**RE: Addendum to the Contract Documents for the West High Service Pump Station  
Bid No. ITB-4221**

**ADDENDUM NO. 3  
TO  
BID DOCUMENTS  
FOR  
WEST HIGH SERVICE PUMP STATION  
FOR THE  
CITY OF ANN ARBOR, MICHIGAN**

WEST HIGH SERVICE PUMP STATION  
 Ann Arbor, Michigan

Title  
 STRUCTURAL FOUNDATION SECTIONS

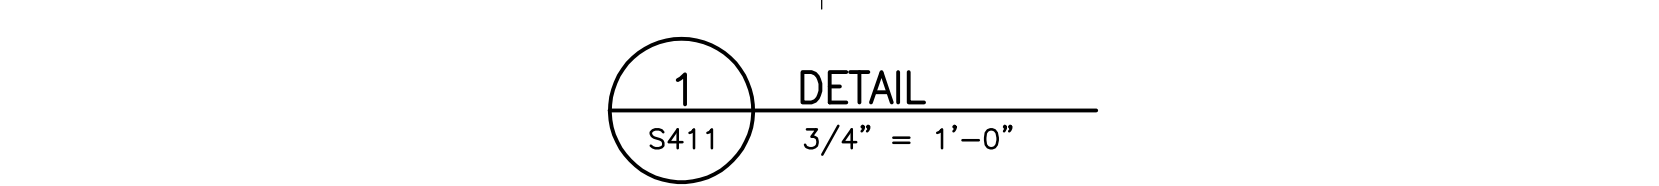
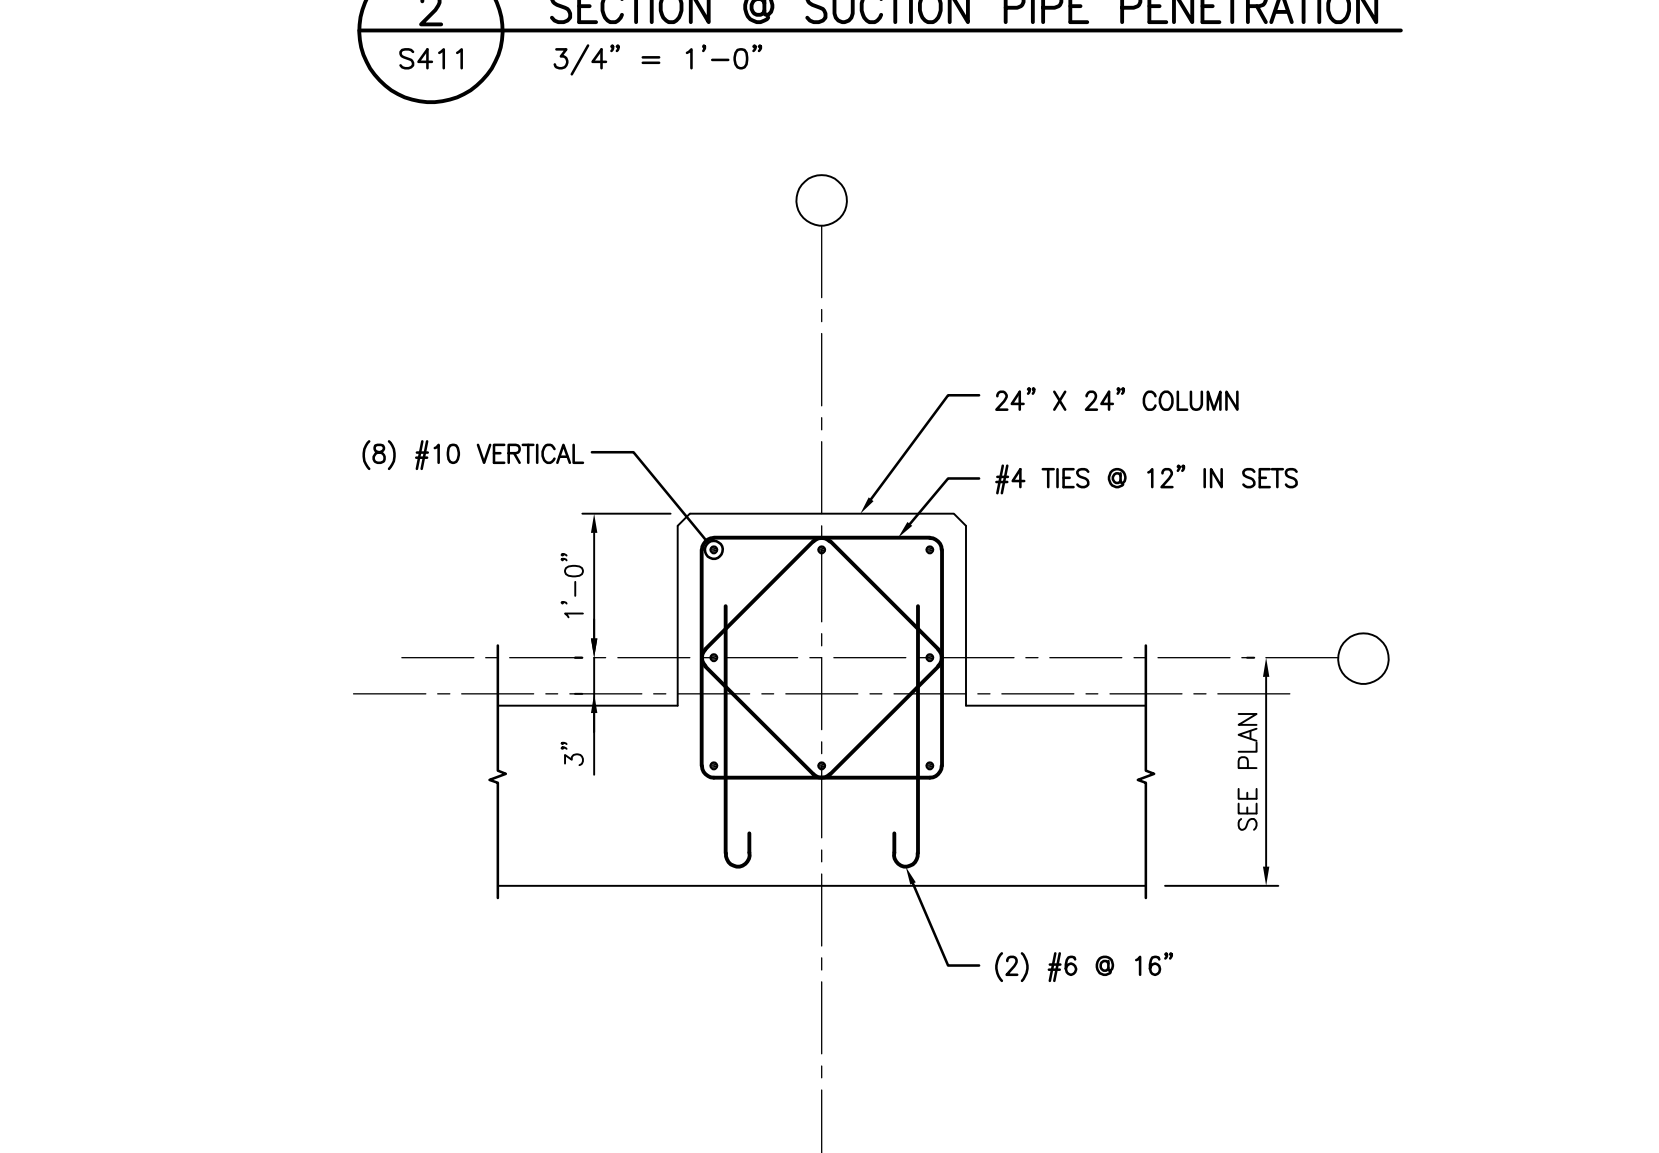
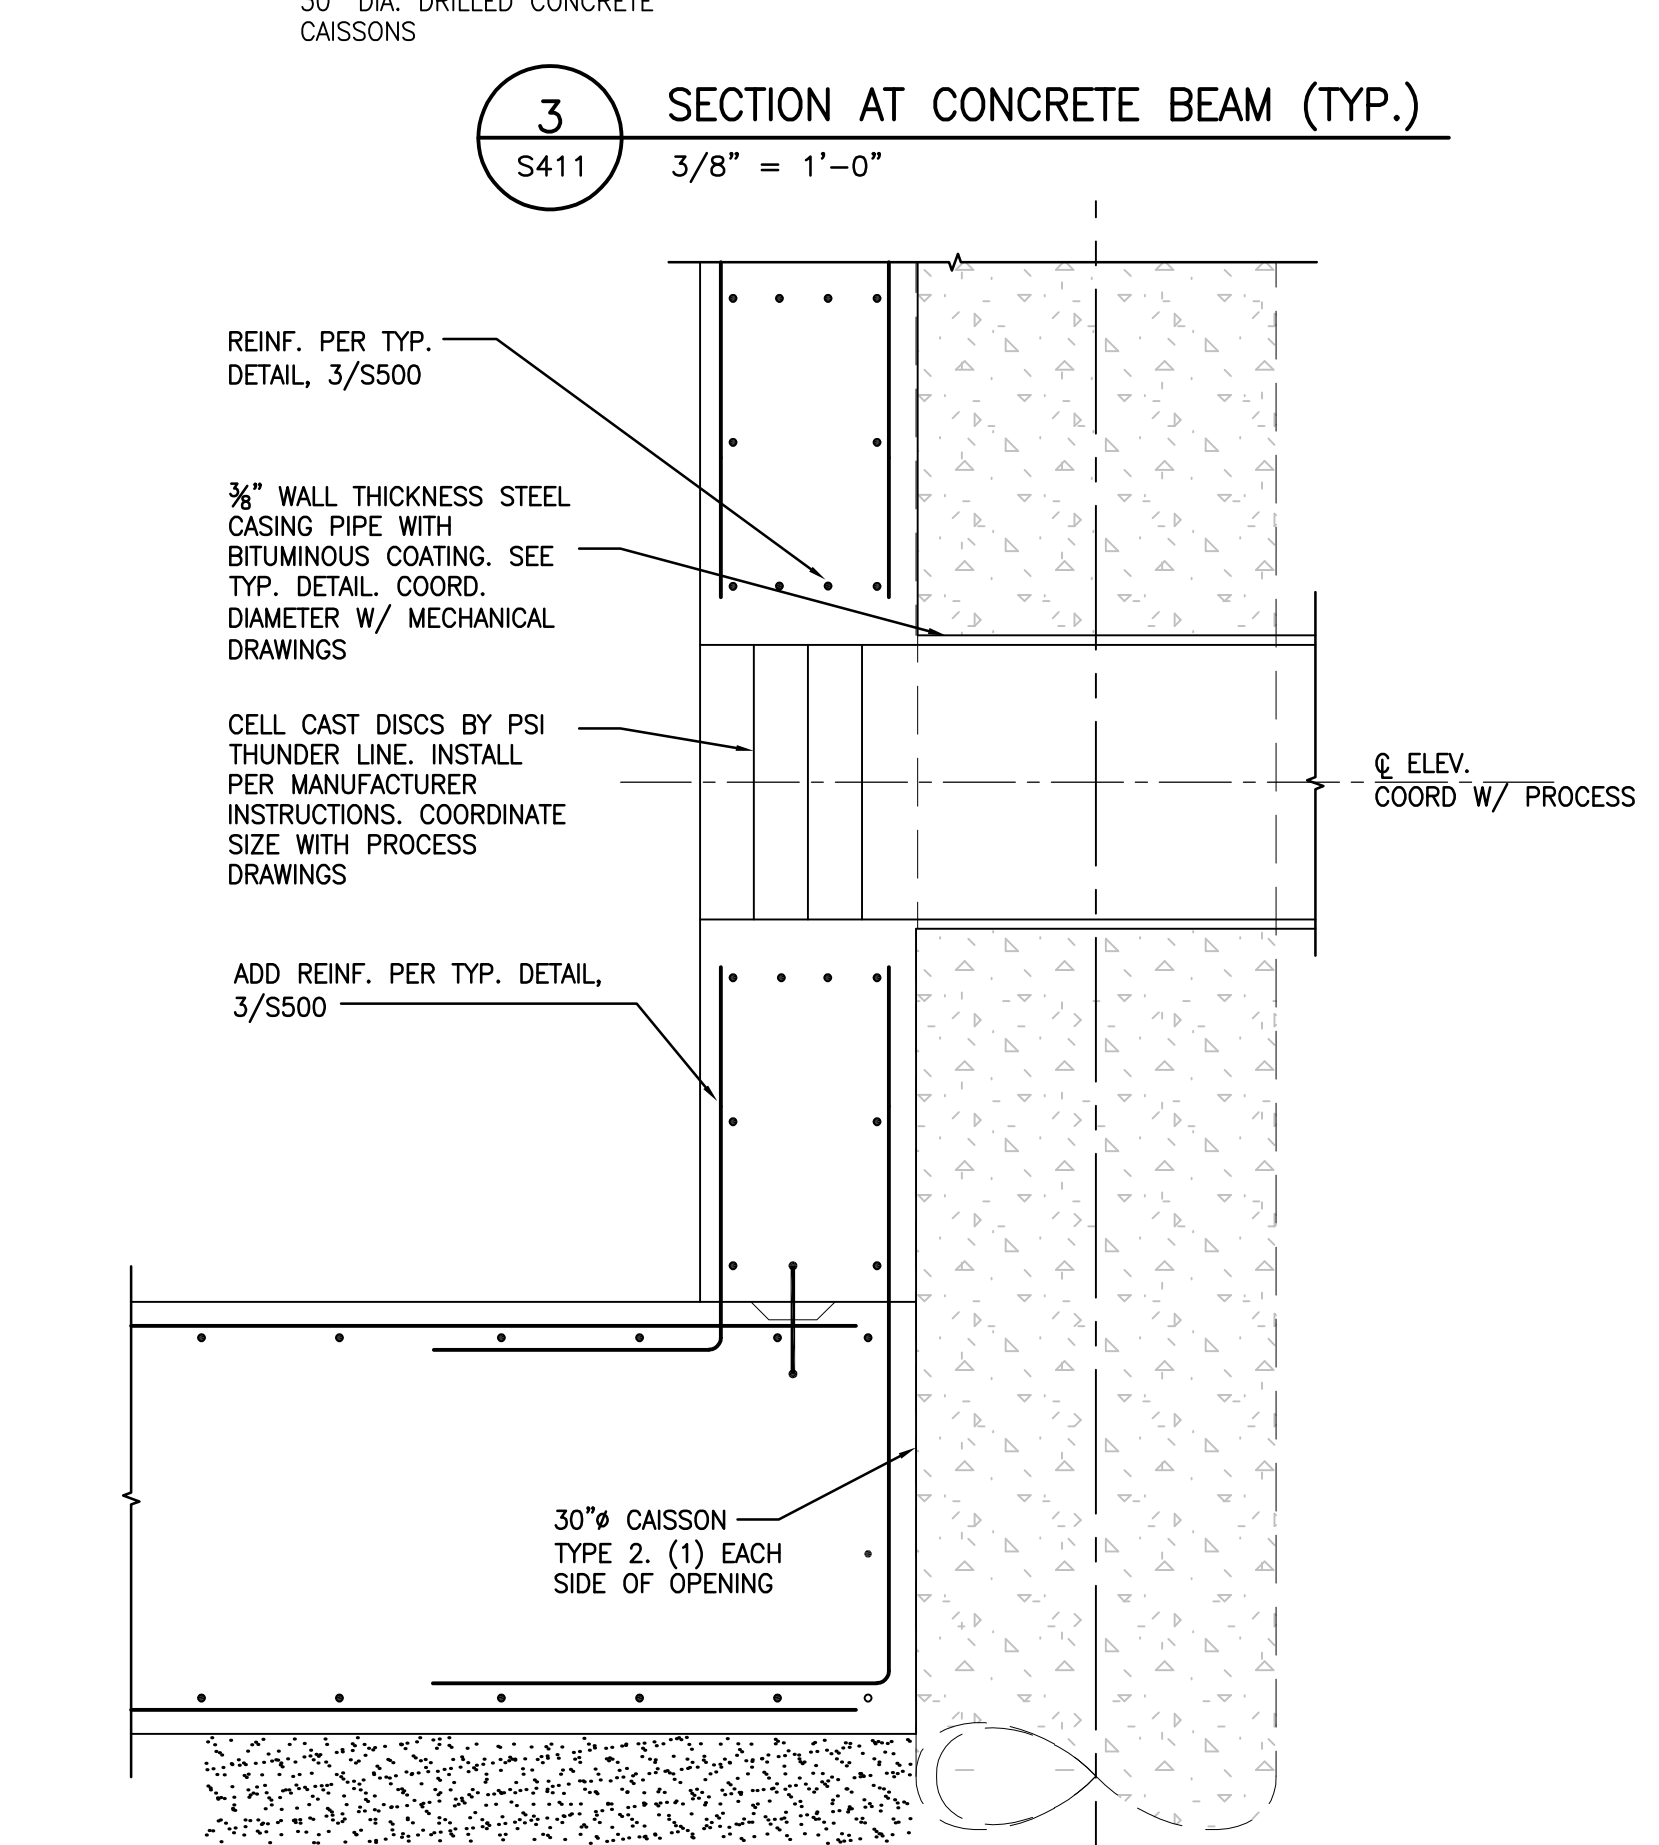
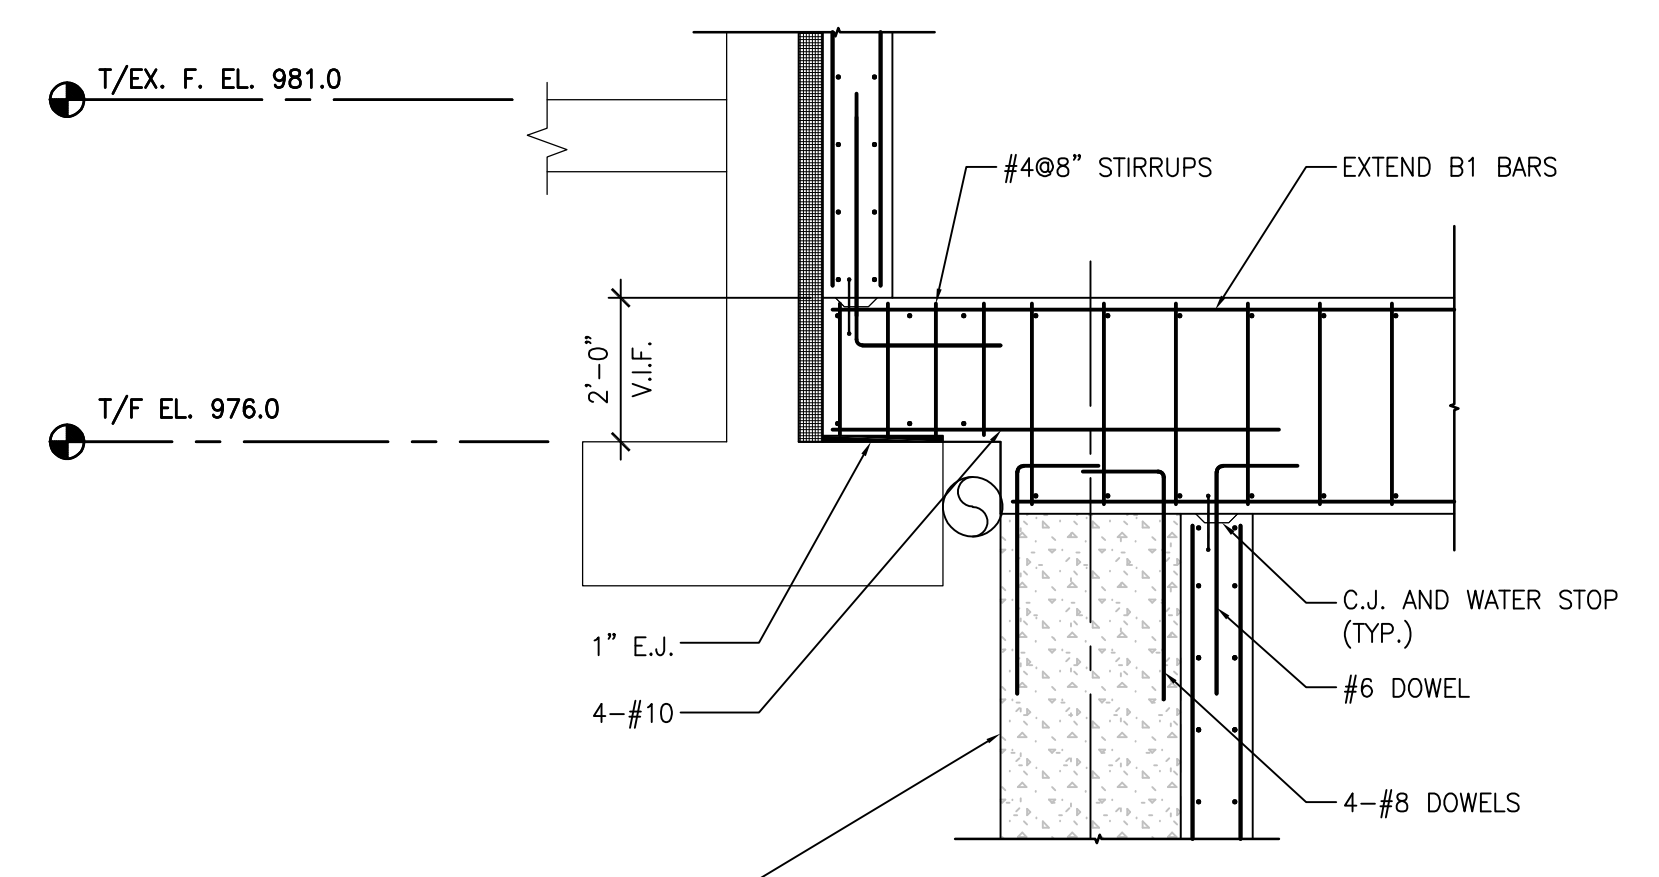
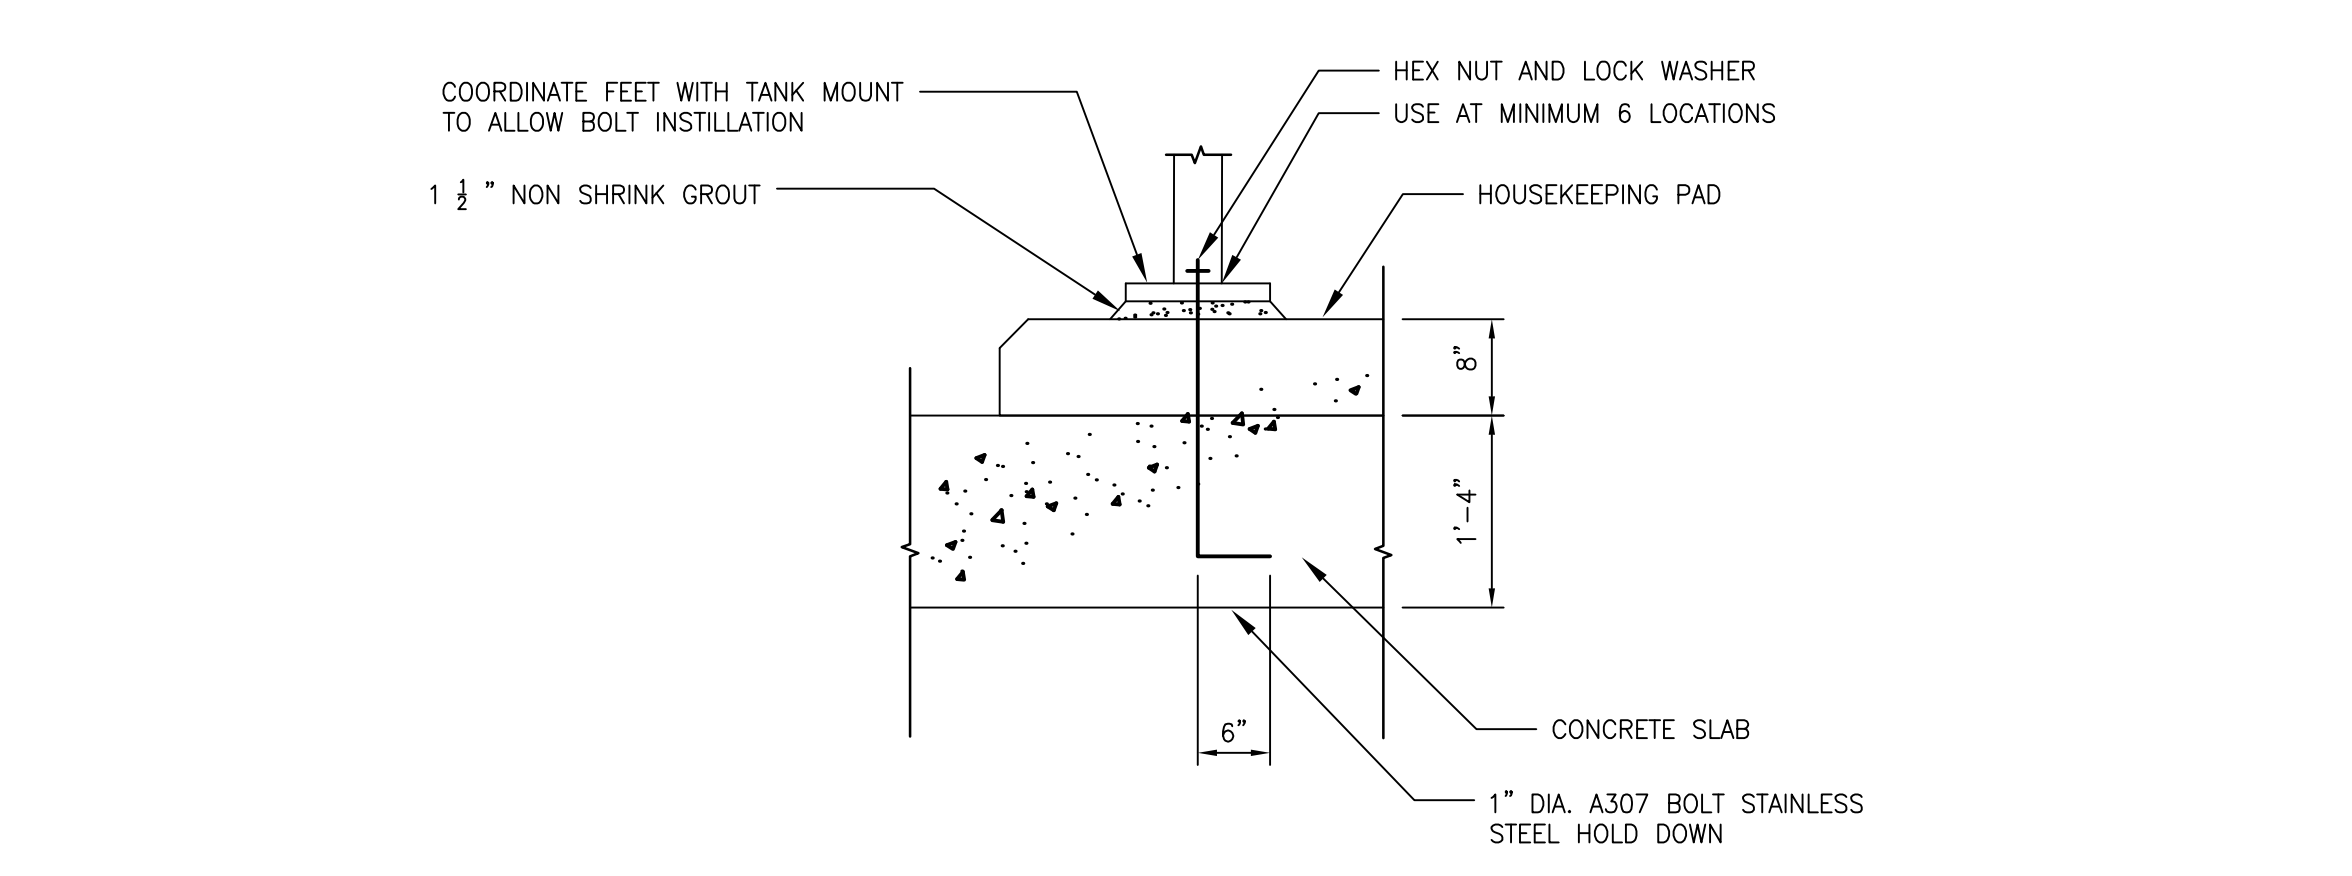
**Revise** Drawing S-411 to add canopy detail notes.
